Project	IEEE 802.16 Broadband Wireless Access Working Group < http://ieee802.org/16 >	
Title	Entering the community using coexistence proxy	
Date Submitted	2006-02-28	
Source(s)	Phillip Barber, Wu Xuyong, Pan Zhong, Zhao Quanbo, Huawei Huawei Industrial Base, Bantian, Longgang, Shenzhen 518129 P.R.C	Voice: +86-755-28780808 PBarber@BroadBandMobileTech.com wuxuyong@huawei.com
Re:	80216h-06_005: Call for Comments and Contributions: IEEE 802.16 License-Exempt Task Group (2006-02-06)	
Abstract	Broadcasting the IP address of BS is putting the BS into risk of being attacked from the internet, to use coexistence proxy between BSs in coexistence negotiation and cooperation could be a way out.	
Purpose	To consider a acceptable way of delivery the contact information between BSs in a community.	
Notice	This document has been prepared to assist IEEE 802.16. It is offered as a basis for discussion and is not binding on the contributing individual(s) or organization(s). The material in this document is subject to change in form and content after further study. The contributor(s) reserve(s) the right to add, amend or withdraw material contained herein.

Entering the community using coexistence pr

Figure hxx. IBS entering the community by neighbor update request broadcasting

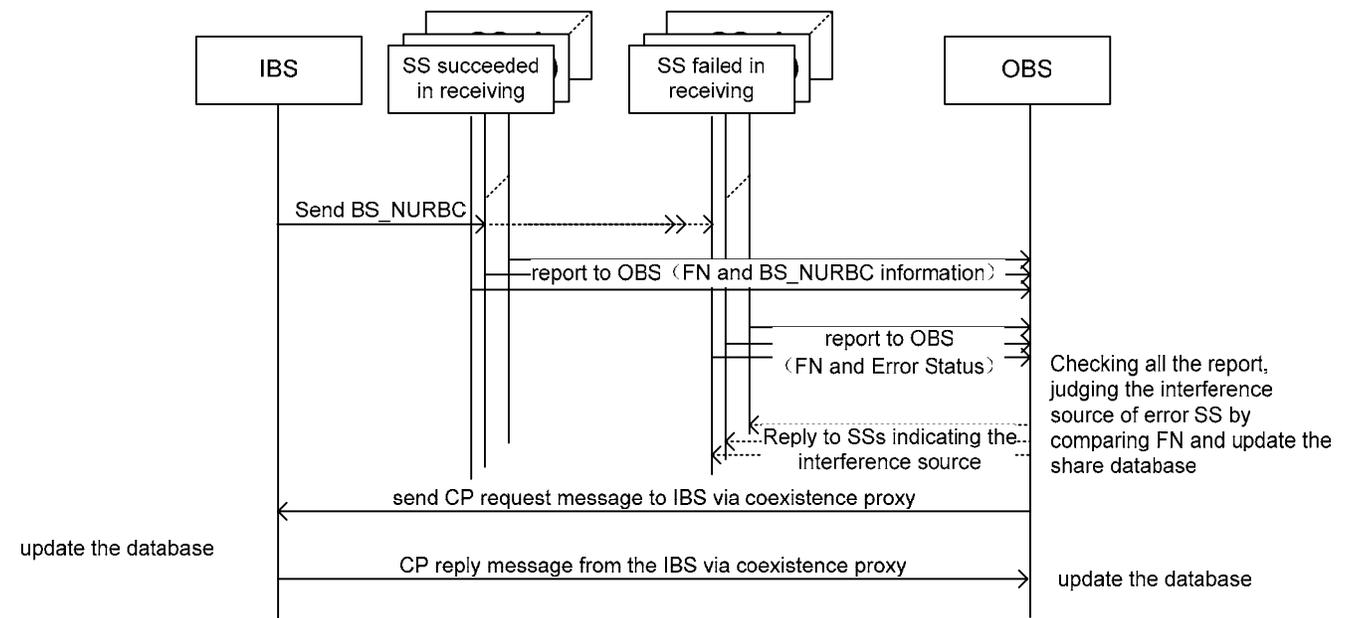
The BS NURBC (see 15.6.6.2.1) broadcasting procedure is unidirectional, only from the BS to the SSs in common coverage of the BS and its neighbors', and the SSs shall report all the useful information to their OBSs they associated to. The SSs that succeed in receiving the message should report the content of BS NURBC and the frame number of the starting frame of BS NURBC, the SSs which failed to received the broadcasting message but got BS NURBC like as interference in the CTS should report the error status and the starting frame number of receiving the interference in CTS. IBS use ICTS to broadcast BS NURBC message, the content in the message will enable its neighbor systems to communicate with the IBS in the IP network to coordinate by coexistence protocol. By the IP address of IBS's coexistence proxy and the BSID reported from the SSs with RTK, the OBSs will then communicate with the IBS in the IP network via their coexistence proxy, and go further coordinate using IP network. And by checking the frame number in the report, OBS need to find out if the SSs that report the error status in BS NURBC receiving have got the same interference source, then OBS will update the database and reply to the SSs which have send the error report. (see figure hxx.)

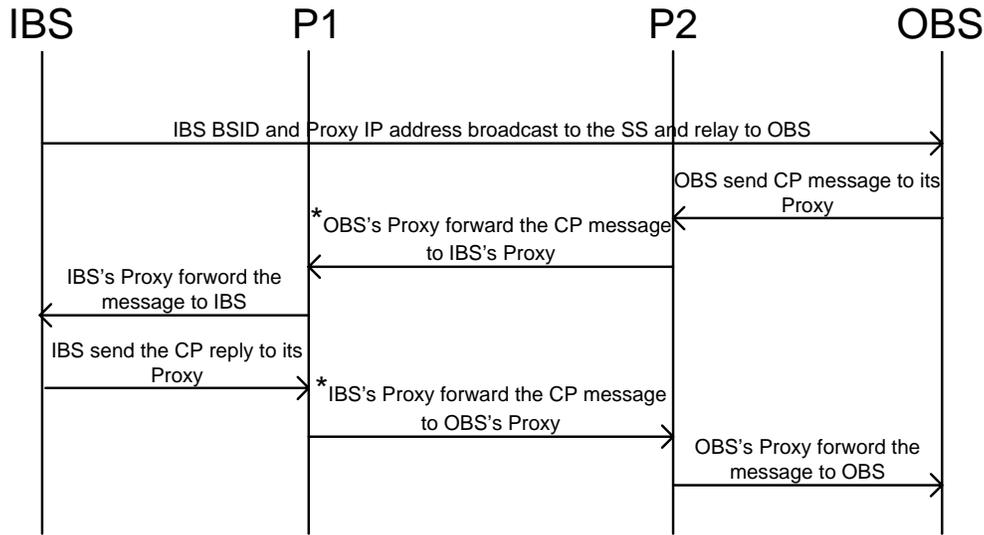
For a new entering BS, it need to know the IP address of its coexistence proxy. By broadcasting the IP address of its coexistence proxy and the BSID of itself, all the neighbor OBSs get these contact information should start to communicate with this IBS through internet via coexistence proxy. After receiving the CP request message from OBS, the OBS's coexistence proxy will then transform the source IP address into the IP address of the proxy, and forward the CP request message to the destination coexistence proxy which serves IBS. The IBS's coexistence proxy should get the destination BSID by parsing the CP request message, and map it into IBS's IP address. If the BSID is in the coexistence proxy service list and find the corresponding IP address, the coexistence proxy should

[forward the qualified CP request message to the IBS. Vice versa, IBS should send the CP reply message to the OBS via the coexistence proxy after receiving and processing the CP request message.](#)

Figure h18a – System Architecture type 2

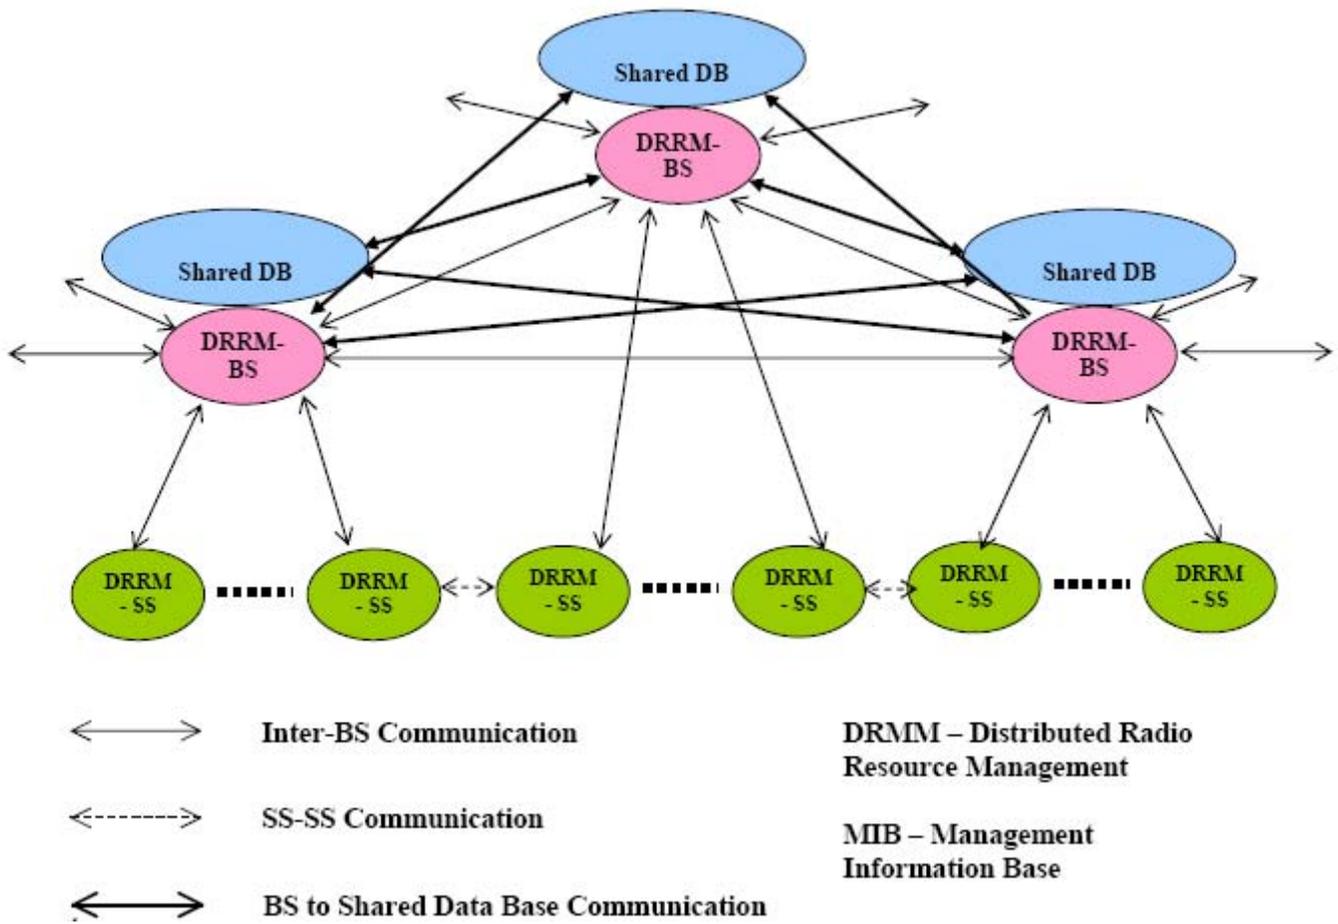
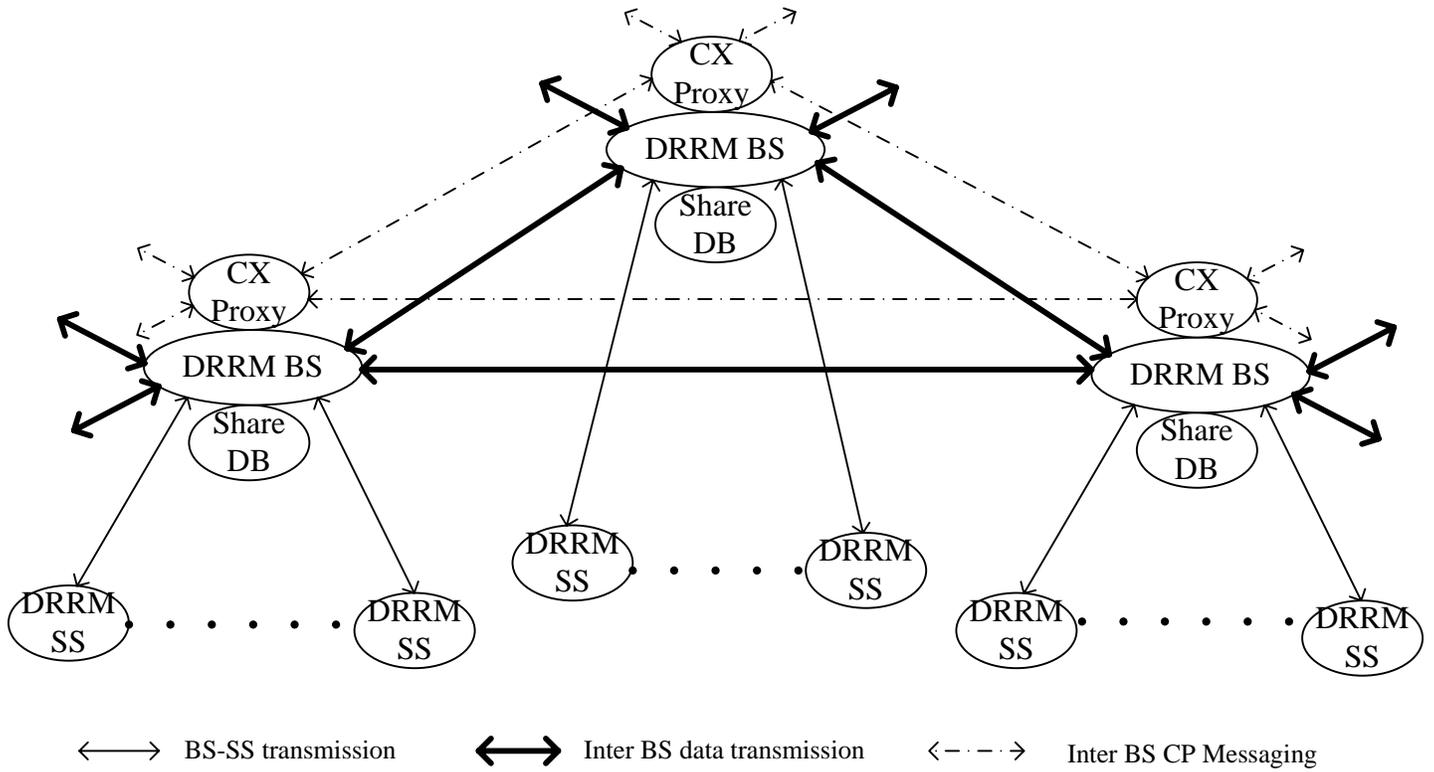
The architecture for Radio Resource Management in the context of IEEE 802.16h it is a distributed one and allows communication and exchange of parameters between different ~~networkssystem~~s. A ~~network-system~~ consists from a ~~Base-Station-base station~~ and its associated ~~Subscriber-subscriber Stationsstations and its coexistence proxy~~.

A subscriber ~~S~~station may include an instance of DRRM, adapted to SS functionality in 802.16h context. The following figure shows the functional diagram of the IEEE 802.16h network architecture:

Figure h19a – Network architecture type 2

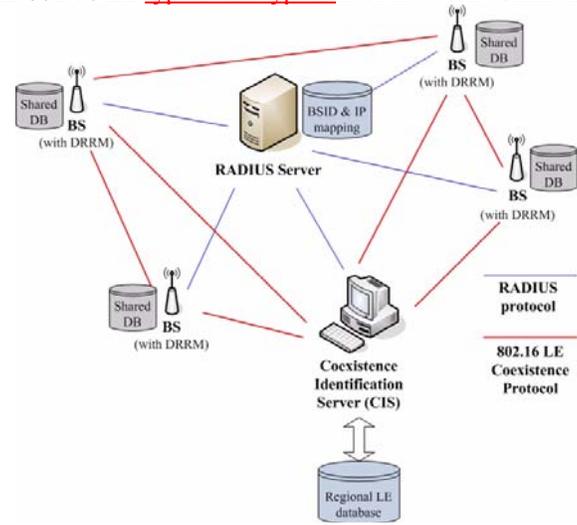
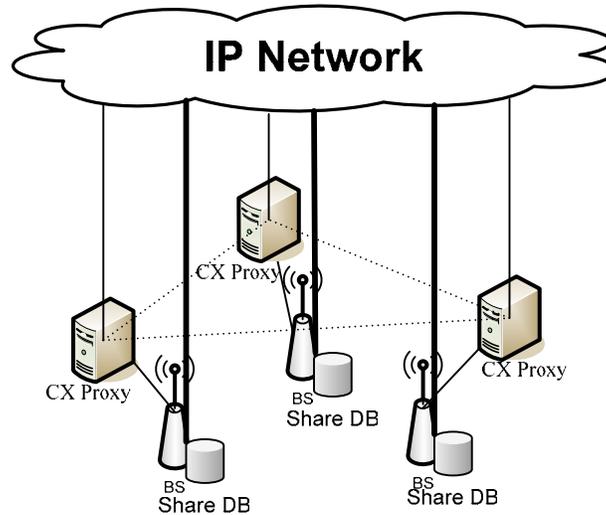
Figure h19. **Figure h19a** shows the IEEE 802.16 LE **type 1 and type 2** inter-network communication architecture:

- The coexistence proxy of every base station maintains the mapping of the IP address and the BSID of their serving BSs. All the CP messages between the different systems should be sent and received via their coexistence proxies instead of directly between the base stations. So the IP address will not be known outside the system. The coexistence proxy will forward the CP messages for the base station.
